### **Proposed Gypsy and Traveller Site, Bradbury Farm, Crick**

#### **Noise**

### Part 1- Clarification on methodology

Figure below has been taken from February 2024 Mott MacDonald: Proposed Gypsy and Traveller Site, Langley Close, Magor "Figure 5.1: Areas within TAN 11 NEC categories", page 18.

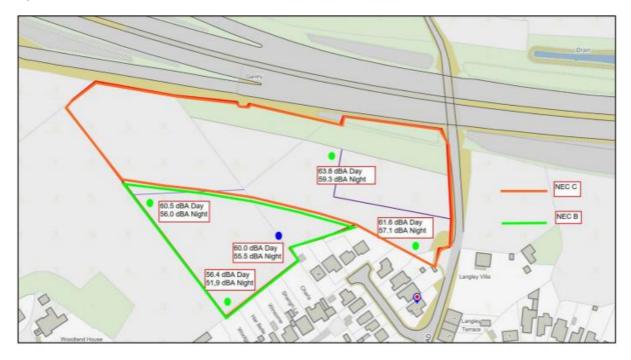
Considering TAN 11 as above - with specific regard to the area falling within NEC 'C' - this is a very large (albeit unspecified) portion of the site footprint and would limit the number of pitches as planning consent is recommended to be ruled out of these areas without enforceable noise mitigation planning conditions in place.

The areas of the proposed site that fall in the NEC C should not be developed for accommodation or outdoor living area. The NEC B area of the site, TAN11 states that "Noise
